<b>Works Approval Number</b>	W6132/2018/1
<b>Works Approval Holder</b>	Wodgina Lithium Pty Ltd
<b>ACN</b>	611 488 932
<b>File Number:</b>	DER2017/001949
<b>Premises</b>	Wodgina Operations Mining tenements M45/50, M45/381, M45/382, M45/383, M45/886, M45/887, M45/923, M45/925 and M45/1252 MARBLE BAR WA 6760
<b>Date of Amendment</b>	<b>23 September 2019</b>

## Amendment

On the 7 June 2019, Wodgina Lithium Pty Ltd (WLPL) submitted a works approval amendment application to extend the commissioning period for Beneficiation Plant Train 1 and TSF3 Extension (TSF3E) beyond 90 days. WLPL also requested approval to commission Beneficiation Plant Train 2 with ore. The Amendment was granted on 12 July 2019, but commissioning of Train 2 with ore was not approved at this time due to issues identified with the site water balance.

**Figure 1:** Wodgina Lithium Mine – Environmental receptors. The red dotted line depicts TSF3E, the blue lines represent pre mining surface water drainage lines.

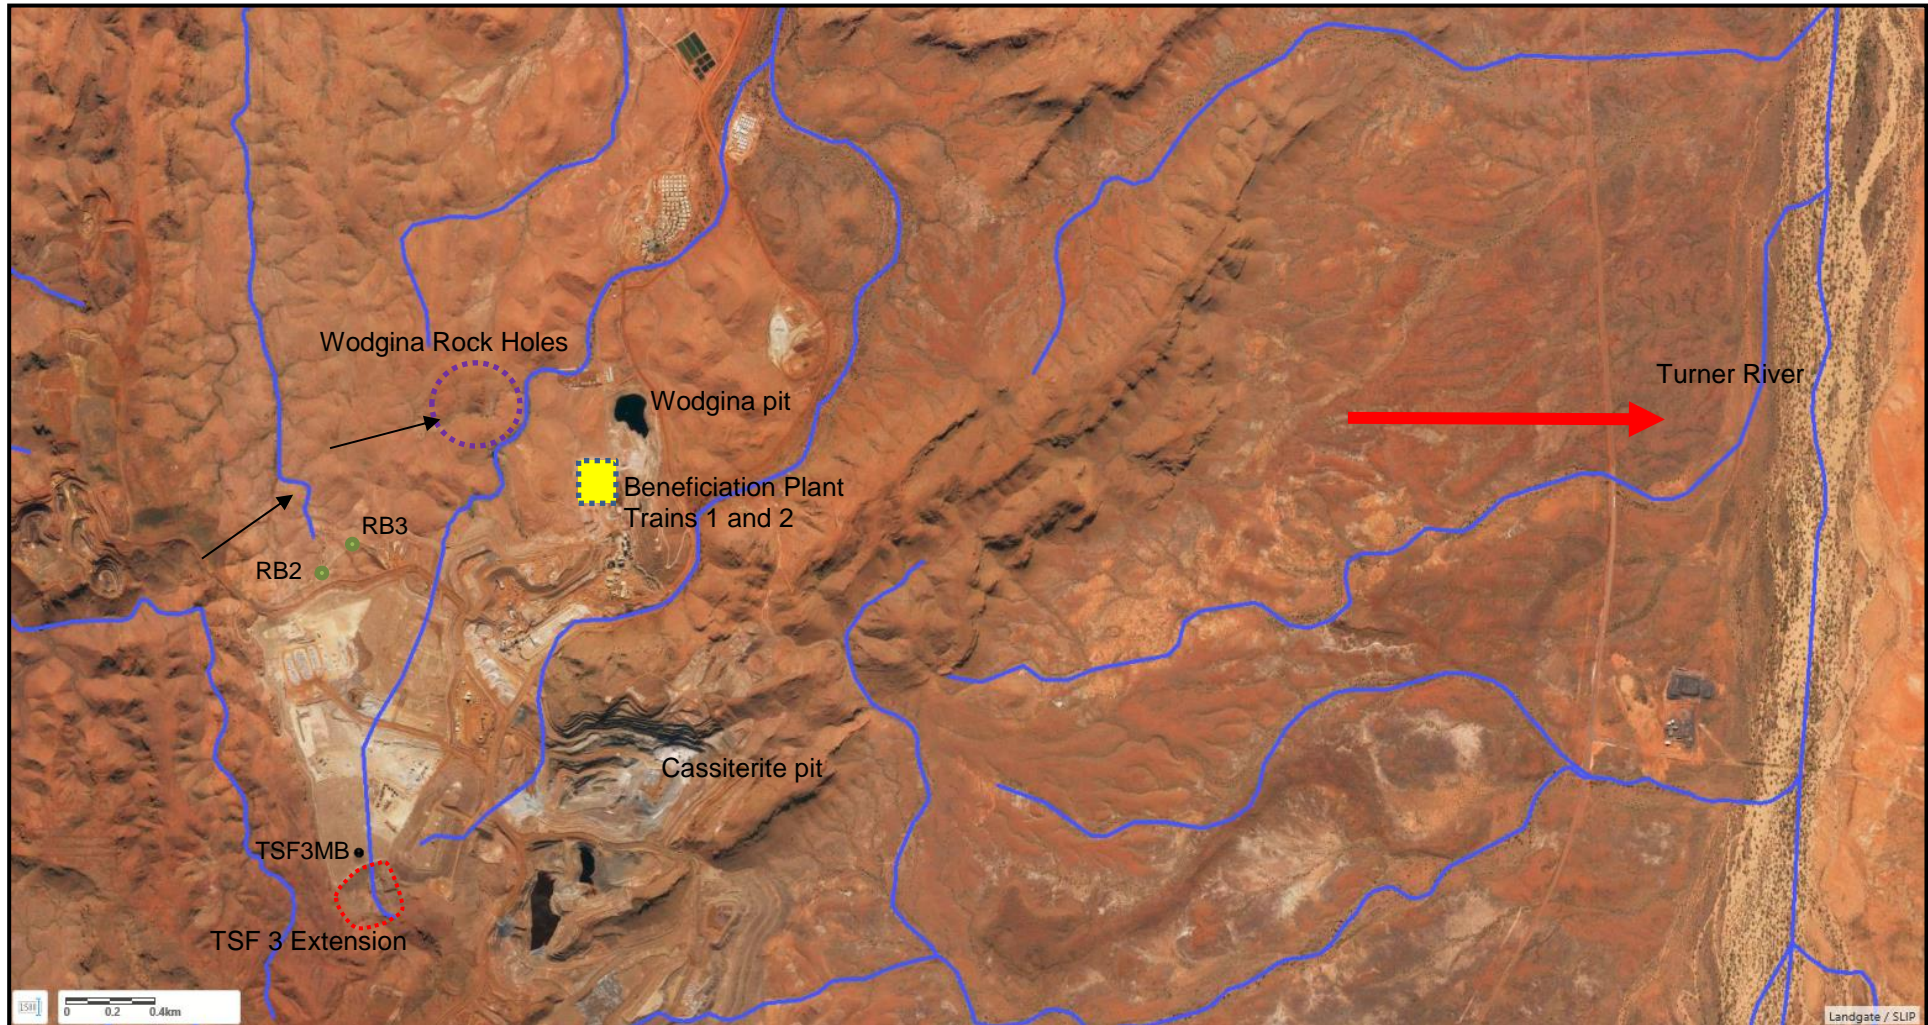
Condition/ page	Summary of Works Approval Holder comment	DWER response
Page 6: Change to label of Figure 1.	Requested removal of reference to surface water lines' and replacement with pre-mining surface water drainage lines.	Minor change – figure 1 label updated.
Page 8: Text states: Water balance calculations were presented in Appendix E (Figure 2). In the outflow losses from the tailings dam, the return water balance to the plant has been designed to use on average, 50% of tailings water recovered.	WLPL has requested this be removed, stating: <i>It is noted that the seepage analysis model used a simplistic 2D finite element analysis to conservatively estimate groundwater seepage for saturated, steady state operational flow conditions.</i>	DWER disagrees with this comment given.  Figure 2 as part of the CMW TSF3 Expansion Report, was submitted as part of the works approval application (supporting documentation) and used in the assessment of seepage and water management.  While it is noted that the site is currently commissioning, the design and technical specifications remain relevant for assessing against the intended steady state operation long-term, given these were endorsed compliance documents.

**Schedule 1: TSF 3 Extension Monitoring bores location**

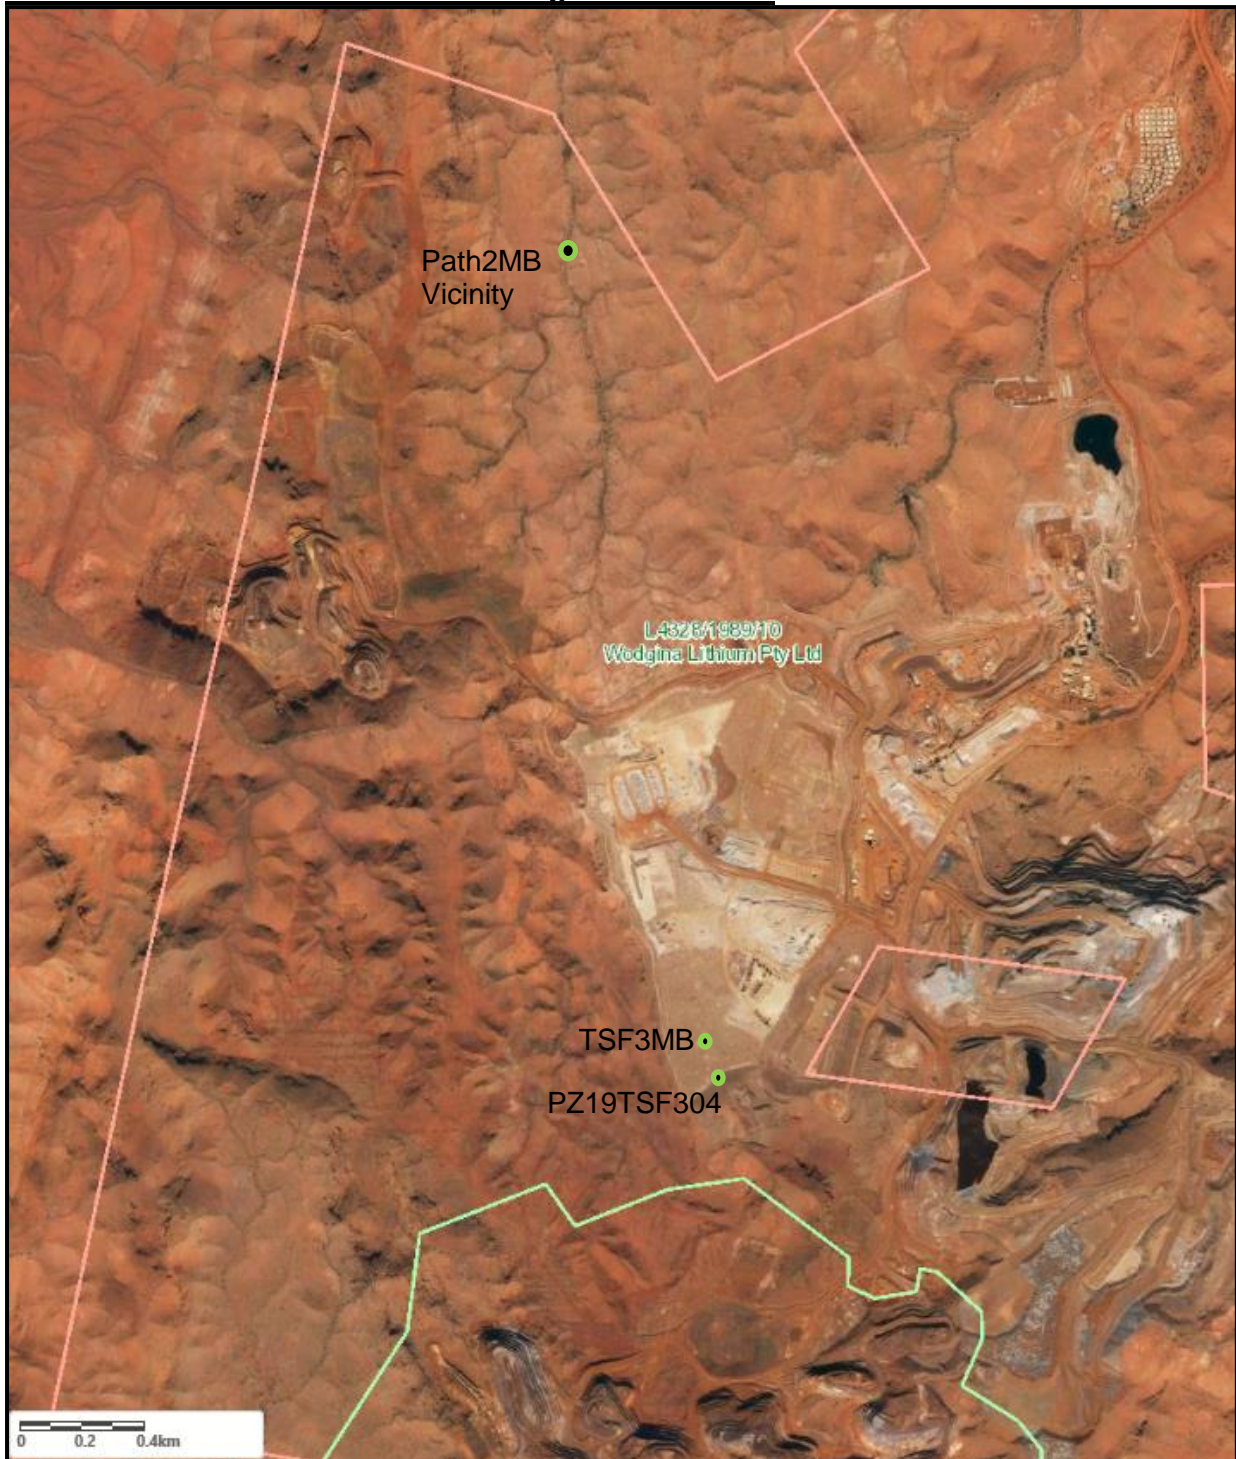
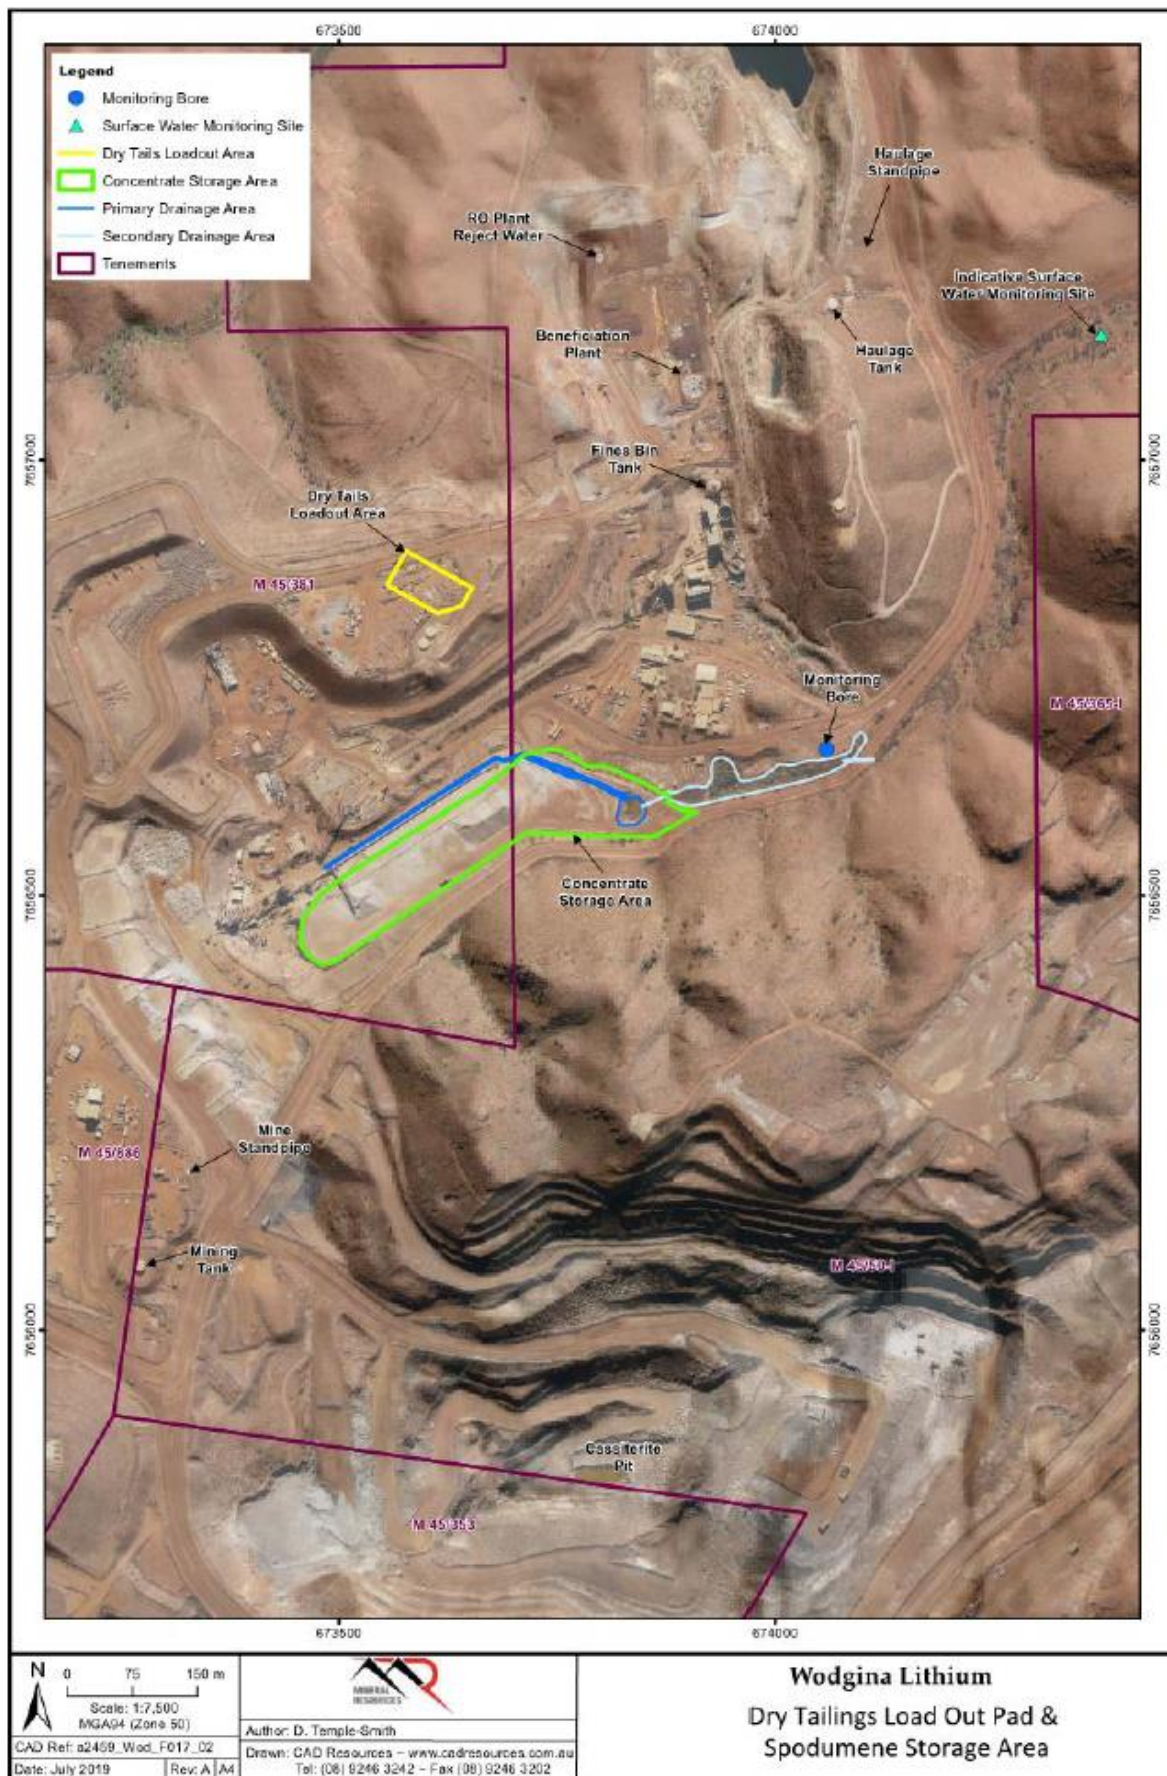
The amendment will also include a new monitoring bore located north of TSF 3 at the identified second seepage pathway with a nominal location provided in Schedule 1.

Additional spodumene storage capacity to facilitate commissioning of the beneficiation train is proposed for the DSO Stockyard Area, as shown in Schedule 1. The Concentrate Storage Area (noting no Dry Tailings Area authorised) will include:

**27. The Works Approval Holder must only store spodumene concentrate outside of the Storage shed on the premises, at the location designated 'Concentrate Storage Area' in Schedule 1.**

**28. The Works Approval Holder must ensure that for the Concentrate Storage Area in Schedule 1:**

<p>Page 14, addition of text referring to monitoring bore</p>	<p>WLPL suggests with a nominal location provided in Schedule 1.</p>	<p>Text added.</p>
<p>Condition 18: at least 50% tailings water recovery.</p>	<p>Amend statement to read:</p> <p><i>....the target of 50% tailings water recovery</i></p>	<p>Updated to target.</p>
<p>Table 4: Recovery Bores RB1 and RB 4</p>	<p>WLPL states RB1 and RB4 are not operational</p>	<p>DWER has removed these but notes these will need to be added to the works approval once operational.</p>
<p>Table 4: Path2MB</p>	<p>WLPL states, this new bore is unlikely to be established prior to the commissioning of all Trains.</p> <p>Currently determining an appropriate location, in consultation with AQ2.</p>	<p>DWER has left this in the table for monitoring and results once the bore is established.</p>
<p>Condition 25:  After 15 December 2019....</p>	<p>Up to the Grant of the License amendment, .....</p>	<p>The intent of this condition is to allow commissioning, then once the time limited operation starts (after the commissioning report has been submitted) for DWER to be updated on exceedances while WLPL apply for a licence application. DWER will then be updated on any issues as the licence for operation is being drafted (up to 15 February 2020).</p> <p>Wording has also been updated to <i>exceedance</i> seeing targets are now referenced.</p>
